# UNITED STATES PATENT AND TRADEMARK OFFICE

APPLICATION NO.	FILING DATE	FIRST NAMED INVENTOR	ATTORNEY DOCKET NO.	CONFIRMATION NO.
10/657,933	09/09/2003	Sunny E.L. Huang	7342	1592
7590	01/19/2005			
Paul M. Denk Ste. 170 763 S. New Ballas Road St. Louis, MO 63141			EXAMINER REIS, TRAVIS M	
			ART UNIT 2859	PAPER NUMBER

## Office Action Summary

## **DETAILED ACTION**

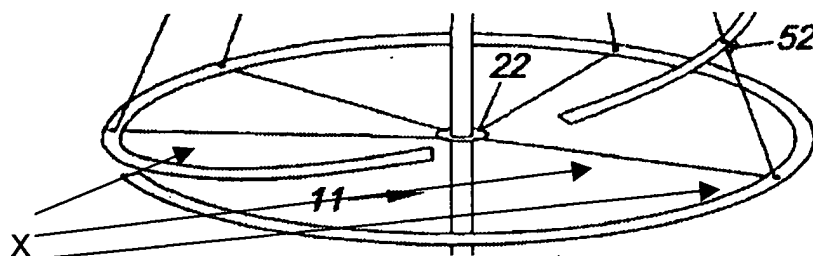
6. Claims 1-3 & 10 are rejected under 35 U.S.C. 103(a) as being unpatentable over Phillips (U.S. Patent 6048590) in view of Ybanez (U.S. Patent 2275711) & Rahman (Des. 421810).

With reference to claims 1, 2, & 10, Phillips discloses a resiliently expandable structure (10) in the shape of a cone comprising a structure (13), having an inherent spiral

configuration formed of a band of resilient polymer material (Abstract); a base member (22) having a span (X, see below)

greater than the largest diameter of said structure and joining said structure at one or more points; a cross brace (21) having a span of the narrowest diameter of said structure, joining said structure at multiple points, and located opposite said base member (Figure 1); and illuminating means (54), regularly arrayed along the length of said band (Figures 1-3).

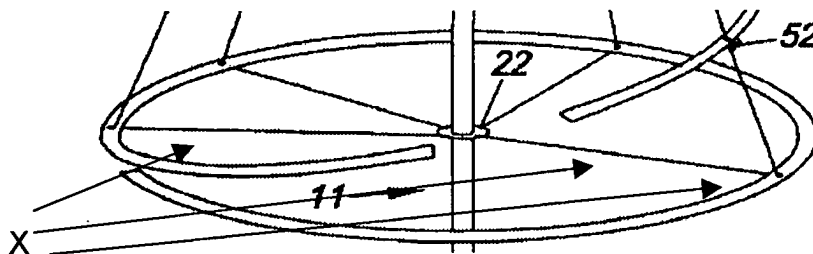
With reference to claims 11 & 12, Phillips discloses a resiliently expandable structure (10) in the shape of a cone comprising a structure (13), having an inherent spiral configuration formed of a band of resilient polymer material (Abstract); a base member (22) having a span (X, see below)

greater than the largest diameter of said structure and joining said structure at one or more points; a cross brace (21) having a span of the narrowest diameter of said structure, joining said structure at multiple points, and located opposite said base member (Figure 1); and illuminating means (54), regularly arrayed along the length of said band (Figures 1-3).
